DESIGN #	DRAWN BY CP	DART AEROSPACE LTD HAWKESBURY, ONTARIO, CANADA	
CHECKED #	APPROVED #	DRAWING NO. DSI 9204	REV. A SHEET 1 OF 1
DATE 01.04.26		TITLE DART 350/355 SKID/STEP INTERFACE NTS	
A	01.04.26	NEW ISSUE

## **DART SERVICE INSTRUCTION**

TO AMEND INSTALLATION DRAWING D350-591 REV. D

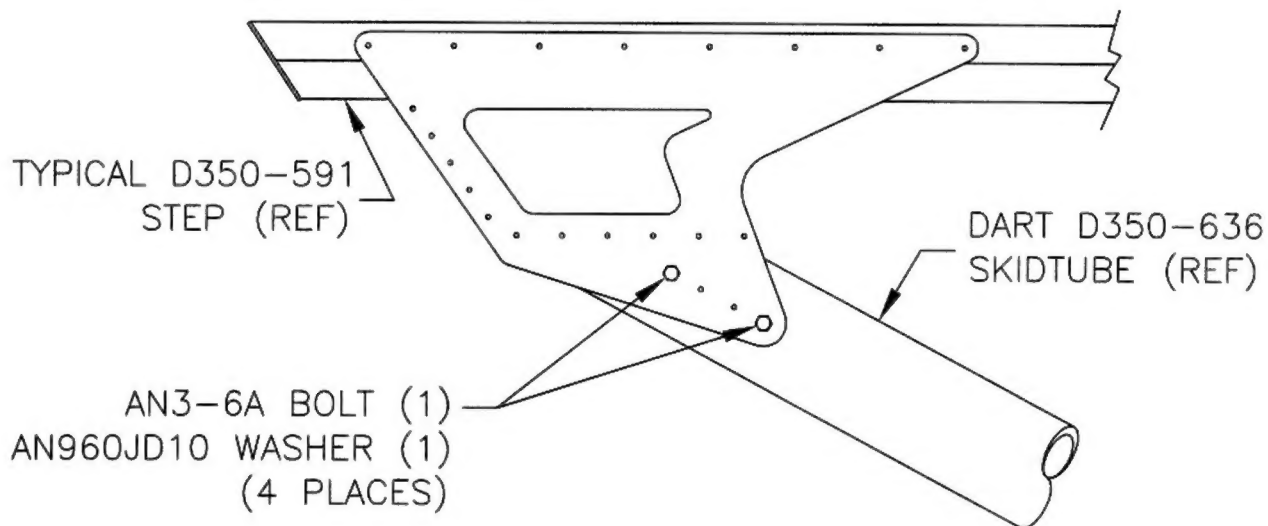
WHEN INSTALLING THE DART D350-591 STEPS ON DART D350-636 SKIDTUBES (REF. CANADIAN STC SH99-7, FAA STC SR00646SE), THE AN3-37A BOLTS (2), MS21042L3 NUTS (2), AND AN960JD10 WASHERS (2) CALLED UP IN THE PARTS LIST OF D350-591 REV. D ARE NOT REQUIRED. USE THE AN3-6A BOLTS (4) AND AN960JD10 WASHERS (4) THAT ARE PROVIDED WITH THE SKIDTUBES INSTEAD, AS SHOWN BELOW.
